Public hearing to be held regarding U.S. 231 and Cline Ave

From: Sarah Moore <sarah.moore@cedarlakein.org>
Sent: Thursday, March 10, 2022 11:17 AM
To: James Landry; Ishrader@indot.in.gov
Subject: INDOT Des. No. 1700022 - 231/Cline Proposed Roundabout Plan
Attachments: indot.pdf

Response to Public Comments - Transcribed from Public Hearing – US 231 at Cline Ave. Intersection Improvement (Des. 1700022)

**Indiana Department of Transportation
ENGINEER'S REPORT
Des No: 1700022
U.S. 231 Intersection Improvement Project
Location: U.S. 231 and Cline Avenue, 2.0 mi E of U.S. 41
RP 295+30
County: Lake**

COR. I.D. = F-30

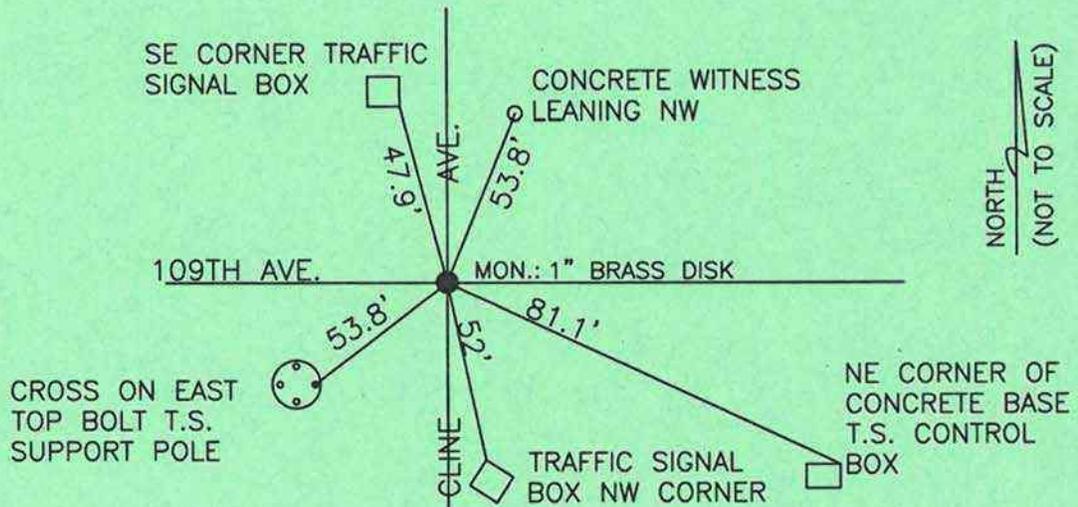
Be it known as of this date that you are now aware that there is a Section Corner Lake County designation F-30 [see attached file] at this location.

Any plans for any improvements to this intersection must include the perpetuation for the location of this Government Section Corner.

<p>Joel Janowski (Lake Co. Surveyor's Office)</p>	<ul style="list-style-type: none"> • Calls attention to a Section Corner Lake County Designation monument located within the project area. • Any plans for this intersection should include the perpetuation of this Section Corner location. 	<ul style="list-style-type: none"> • The section corner monument located near the center of the existing intersection will be reset at the same coordinates, with a new elevation. This is a firm project commitment.
<p>Frank Lendabarker</p>	<ul style="list-style-type: none"> • Stresses that both this intersection and US 231 at Parrish should be two-lane roundabouts, and should be constructed as soon as possible. 	<ul style="list-style-type: none"> • Thank you for your support of this project. INDOT's main priorities are safety and mobility, and your support in these efforts is appreciated. • The idea to construct both this project and the US 231 at Parrish Ave project in the same construction year was explored, but was ultimately considered infeasible due to timing and maintenance of traffic issues. Therefore, the projects will be constructed in separate construction seasons.

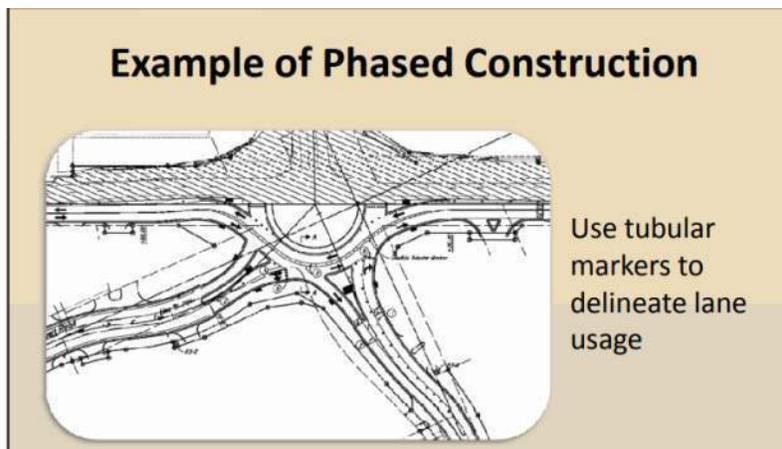
According to this, “The designer is instructed to revisit and refine this strategy.”

The 2022 Report did address the strategy, stated the resulting detour lengths and **times** for both the Cline and Route 231 reroute, but failed to provide the monetary impact to the motoring public.

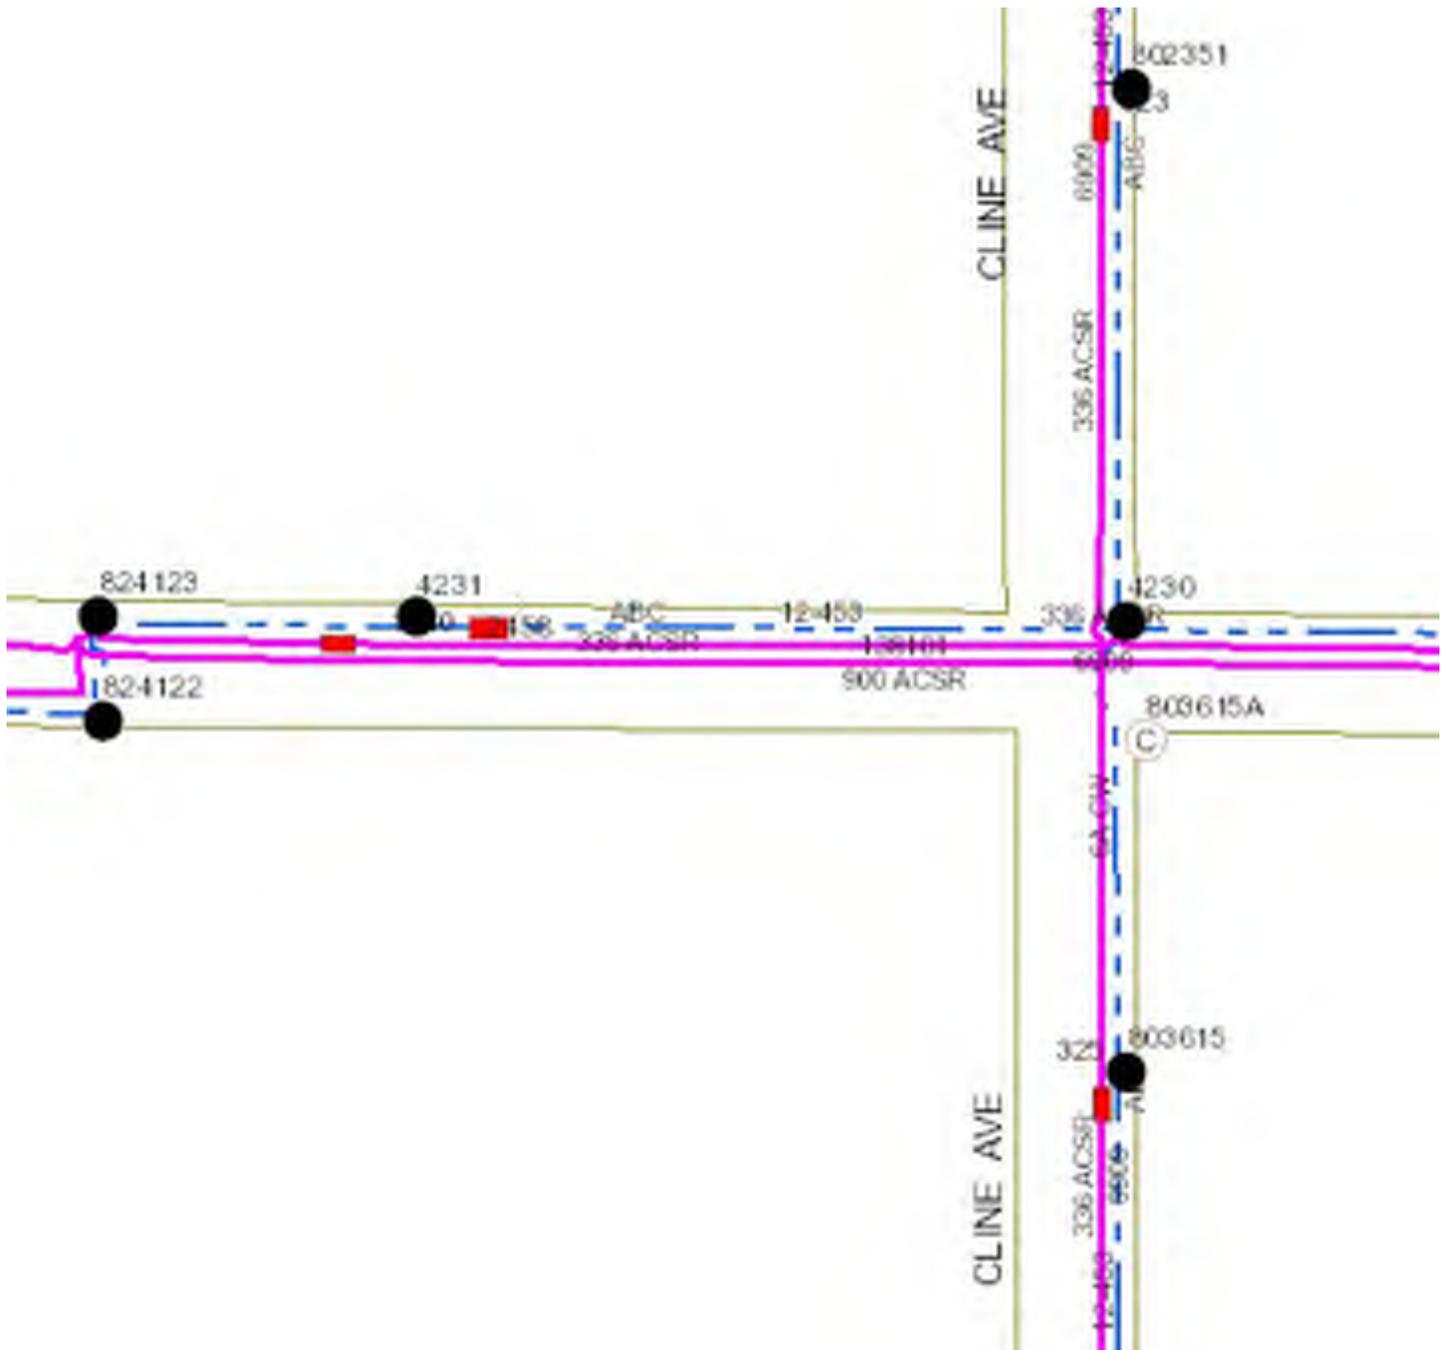
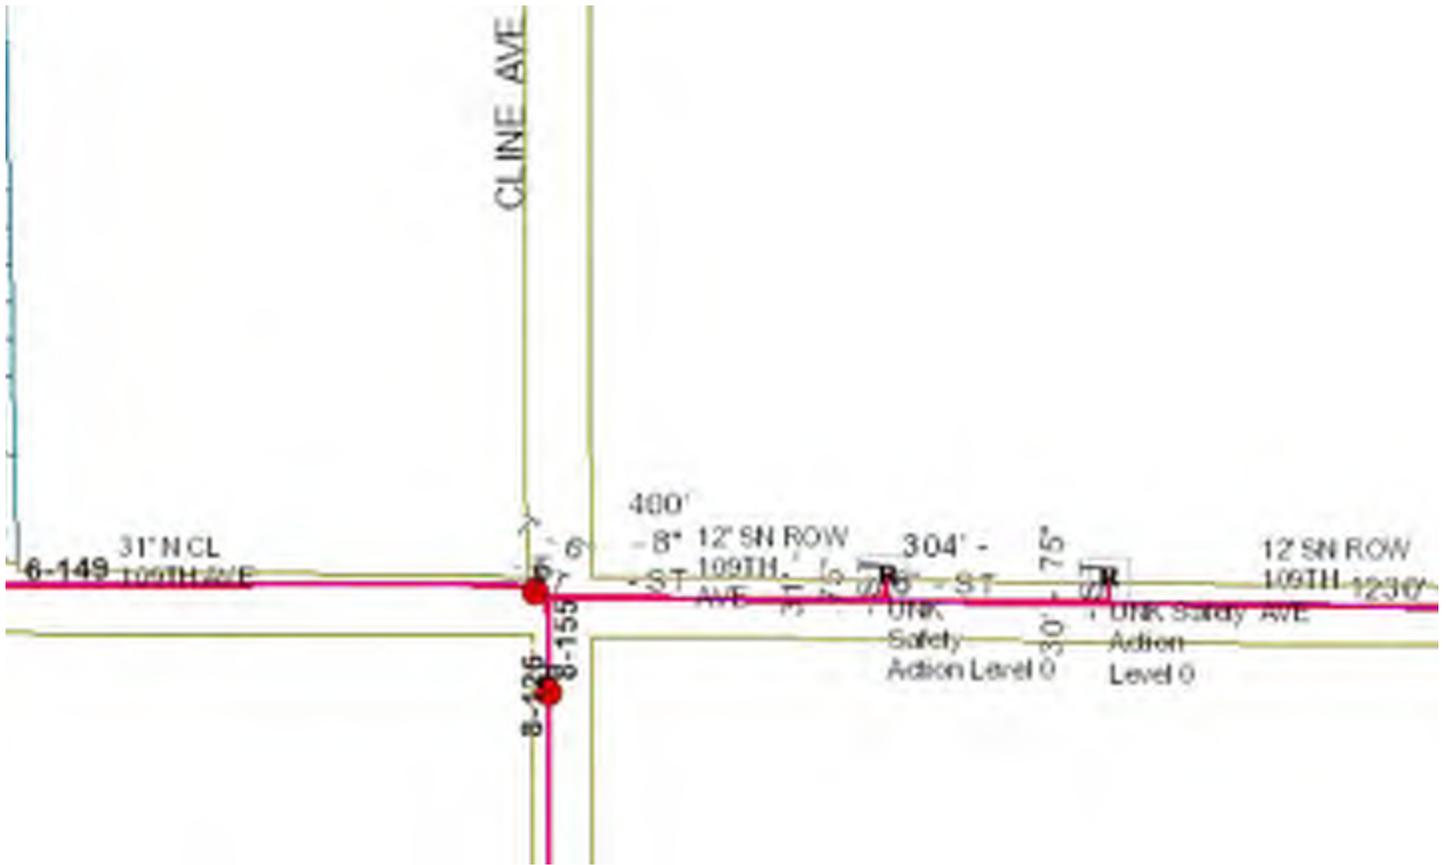
NIPSCO electric GIS, there is a 138 kV pole line with 69 KV and 12.5 kV under build on the north side of US-231. Also, there is 69 kV pole line with 12.5 kV under build on Cline Avenue.

NIPSCO gas GIS, there is a 8" steel gas main on US-231 and a 8" gas main running south of US-231 on Cline Avenue.

I look forward to working with you on this project assuming NIPSCO's gas main is not in conflict with your construction plans. I will need your design plans and proposed grade cuts for review.
